ALERT SERVICE BULLETIN

NO. 212-10-135

MODEL AFFECTED: 212

SUBJECT: Inspection of Transmission Oil Line P/N 70-061L000V360A for Correct Length.

FIGURE 1

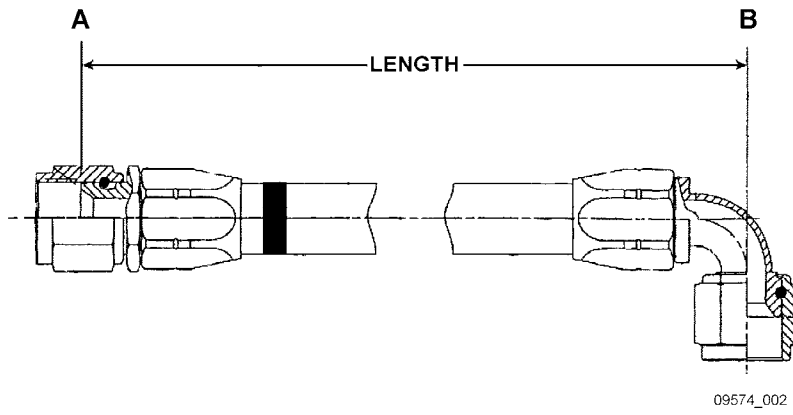
6. Lay the Hose Assembly on a flat surface and measure the length of the Hose as detailed in Figure 1.
7. If the part number 70-061L000V360A Hose Assembly is 36.5 inches (92.71 cm) to 37.5 inches (95.25 cm) then the Hose Assembly must be re-identified, as detailed in step 8.

9. If the Hose Assembly part number 70-061L000V360A measures less than 36.5 inches (92.71 cm) it must be replaced by new part number 70-061L000V370A Hose Assembly prior to further flight.
10. Hoses measuring more than 37.5 inches (95.25 cm) must be replaced by new part number 70-061L000V370A Hose Assembly prior to further flight.
11. Re-install the Hose Assembly and ensure there is no fowling between the Hose Assembly and any airframe components, drive system components, and wiring on the aircraft. See Figure 2 and view "A" for the correct routing of the Hose Assembly.

8. Using a vibrating stylus, vibro-etch a single line through the last four characters of the part number 70-061L000V360A on the tag. Then re-identify the part number of the Hose Assembly as 70-061L000V370AFM.
